# Rezoning Transportation Analysis

Petition Number: 2023-165

Date	Description
01-24-24	First Review (NK)
04-24-24	Second Review (NK)
05-23-24	Third Review (DR)
7-24-24	Fourth Review (NK)
8-27-24	Fifth Review (NK)

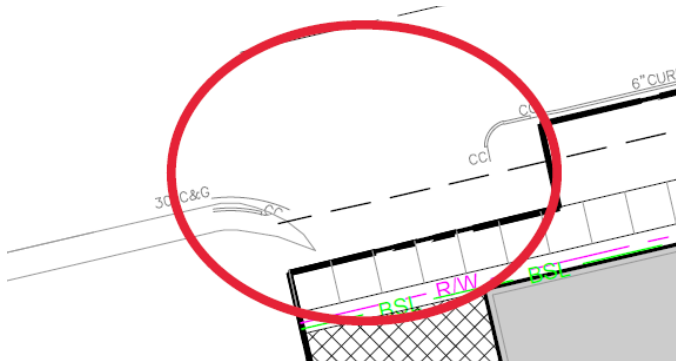
~~5. Revise site plan and conditional note(s) to commit to dedicate 50.5' of right of way from the road centerline. The site plan shall label and dimension the right of way from the Central Avenue road centerline.~~

~~6. Revise site plan and conditional note(s) to commit to dedicate 33.3' of right of way from the road centerline. The site plan shall label and dimension the right of way from the Piedmont Street centerline.~~

~~7. Revise site plan and conditional note(s) to commit to dedicate 18' of right of way from back of curb. Please dimension and label the existing centerline to the existing back of curb that will remain along Sunnyside Ave.~~
